1972 F6-A

PARTS DIAGRAM

SWING ARM/SHOCK ABSORBERS

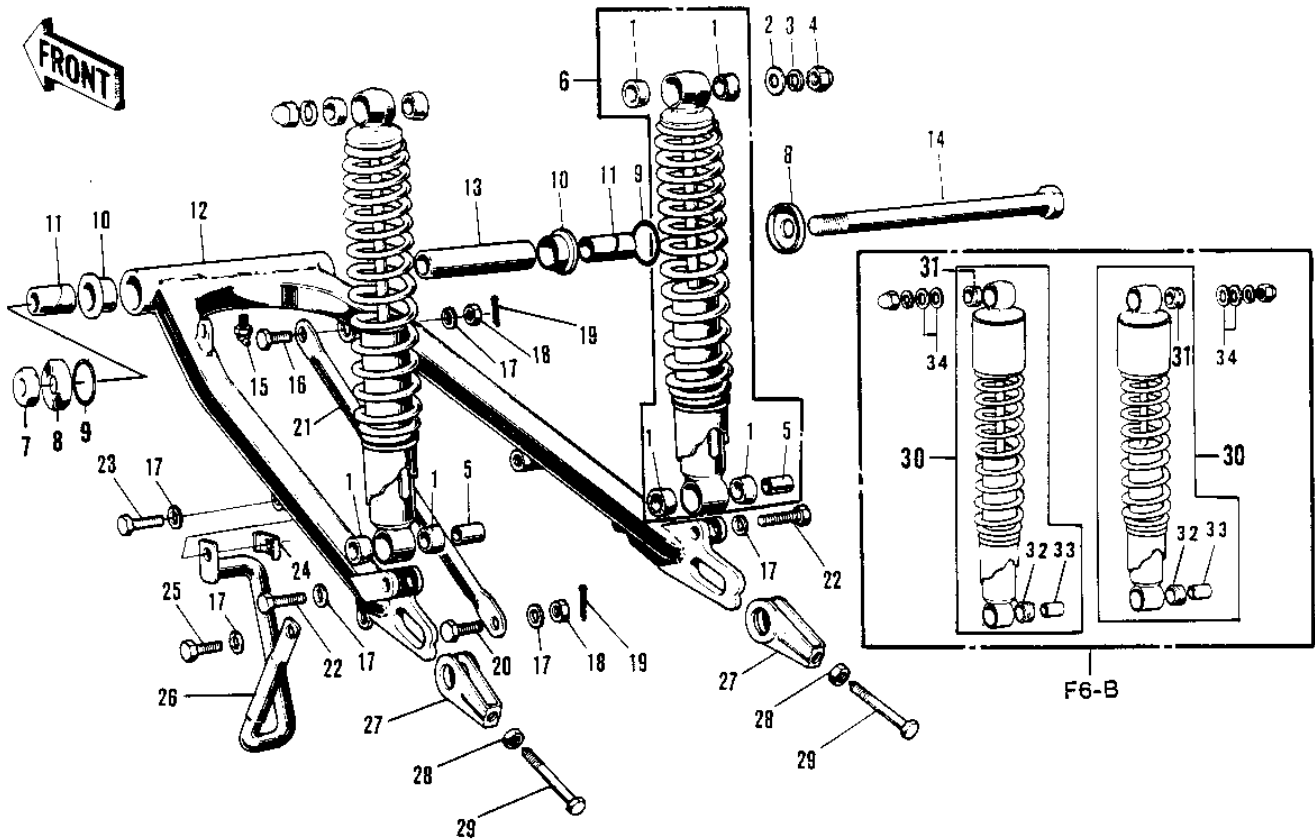
Ref. No. 27, Chain Adjuster		
	OLD	NEW
	1.6 mm 15.2 mm	3.2 mm 13.7 mm
Chain Adjuster	33041-041	33041-048
Collar	42032-027	42032-036
Frame No.	~13329	13330~
Interchange?	Use new parts as a set in place of old parts.
